RotorSport UK Ltd

Service Information Letter

SIL- 021

Subject: Software Upgrade for Digital ASI and Altimeter

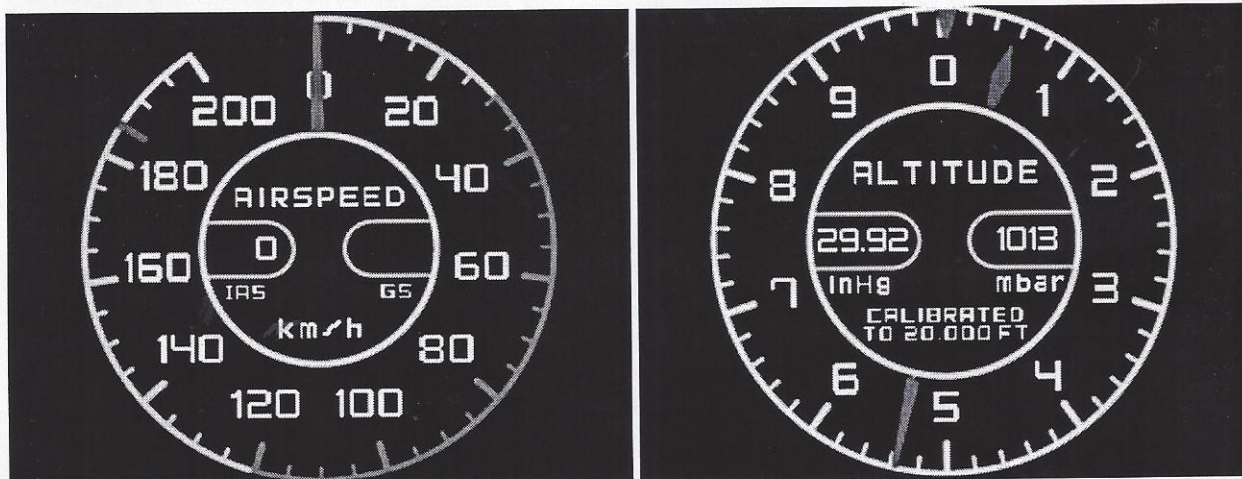
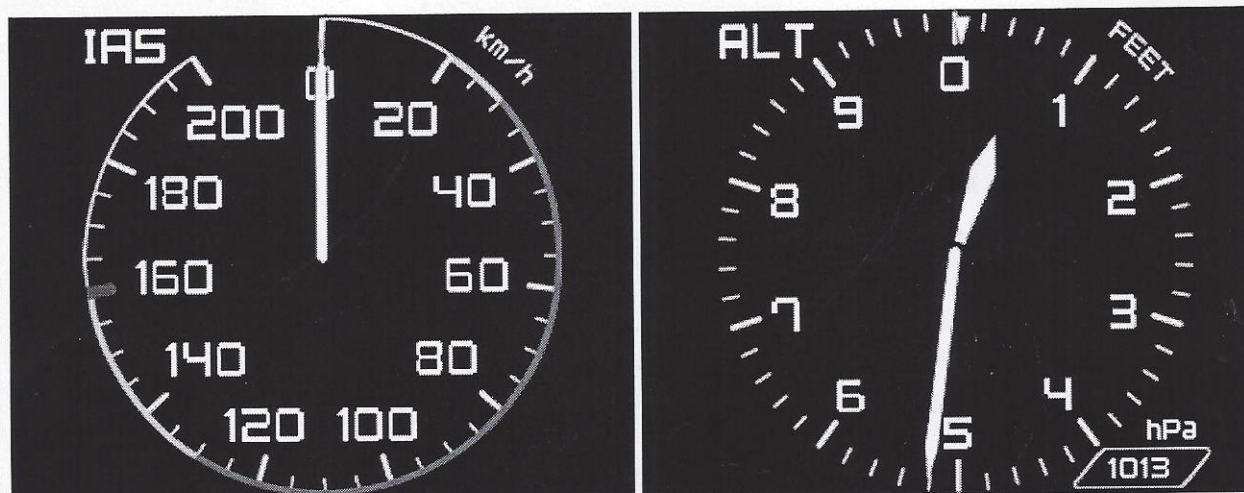
AutoGyro has listened to market feedback regarding the visual appearance of instrument displays, and of the device reliability. The company decided to offer an upgrade to owners that makes the devices easier to read in different lighting conditions, and improves the operational reliability. Any device with a display as shown below may be upgraded to software level 2.17.
